STATE SIGNIFICANT DEVELOPMENT: Section 96(1A) Modification Application

AUSTRALIAN TECHNOLOGY PARK, EVELEIGH

SSD 7317 MOD 1

Environmental Assessment Report Section 96(1A) of the *Environmental Planning* and Assessment Act 1979

Figure 3: Proposed public domain staging plan (Source: supplied by the Applicant)

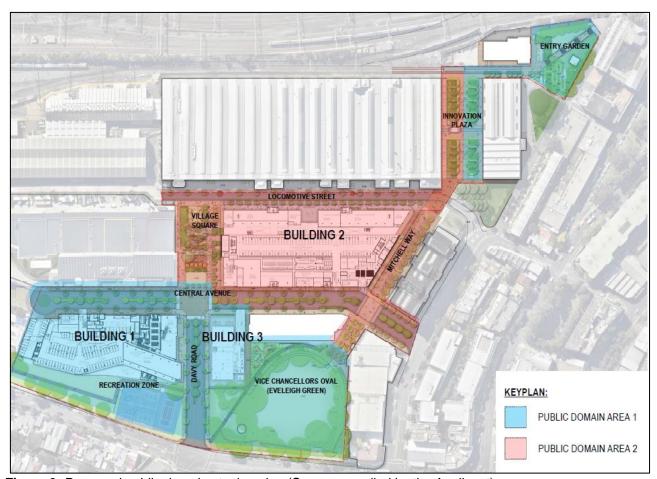
The Department notes the Applicant's project staging plan (**Figure 3**) shows the majority of the public domain will be completed prior to the issue of the OC for Building 1. This includes the Entry Garden, eastern half of Innovation Plaza, Central Avenue north of Building 1, Davy Street south of Village

Square, area south of Building 1 and Vice Chancellor's Oval (Eveleigh Green). Only the public domain area immediately surrounding Building 2 (namely Village Square, Locomotive Avenue north of Building 2, Central Avenue south of Building 2 and Mitchell Way) and the remainder of the Innovation Plaza will be delivered at the later stage.

The Department notes that Condition A16 will need to be amended to reflect the Applicant's project staging plan, which will deliver Davy Road (south of Village Square), the Vice Chancellor's Oval (Eveleigh Green) and western half of Innovation Plaza in Public Domain Area 1 and not Public Domain Area 2 as currently expressed in the condition.

The Department supports the staging of the public domain areas as proposed, noting that the proposed milestones will provide a sufficient form of surety for the completion of the works whist acknowledging that landscaping treatments are typically amongst the last aspects of a construction project to be completed, as construction activity can damage landscaping and public domain works.

Figure 4: Comparison of access routes during Stage 1 works (above) and Stage 2 works (below)

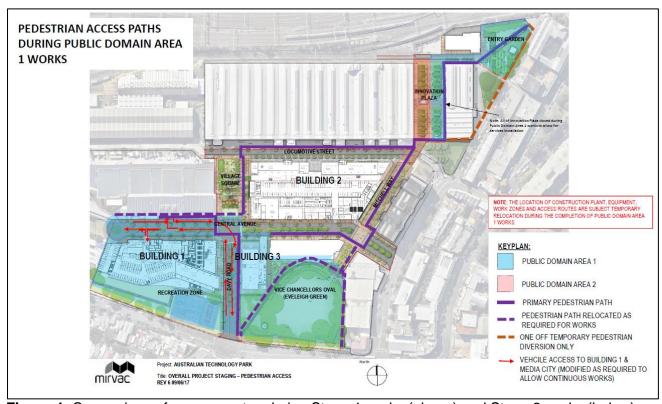
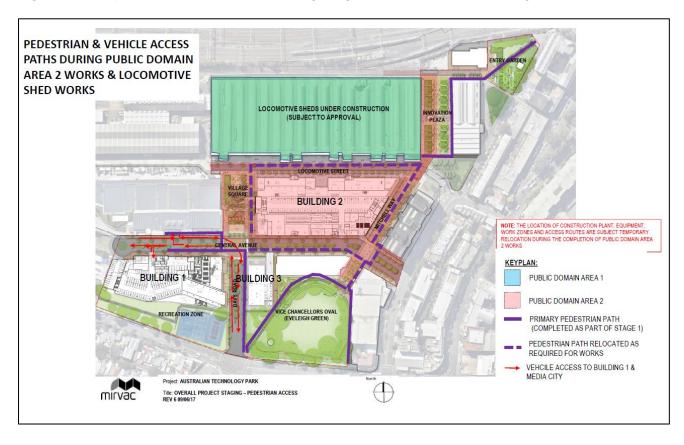
The Applicant justifies the staging by noting it would reduce the restriction of public access through the ATP site during construction works. Public access would be available through the ATP during both stages (**Figure 4**), rather than largely unavailable across the whole site if the works were not staged. **Figure 4** shows that pedestrian access through the precinct will be provided by a primary pedestrian path (during both Stage 1 and Stage 2 works) and connected to a pedestrian path that can be relocated to enable the public domain works in the relevant area to be completed. The Applicant has advised the likely timeframe between occupation of Buildings 1 and 2 is approximately 14 months.

The Department also notes from **Figure 4** that safe and convenient access will be provided to pedestrians through the ATP and vehicle access will be provided to other buildings within the ATP throughout the delivery of the public domain works.
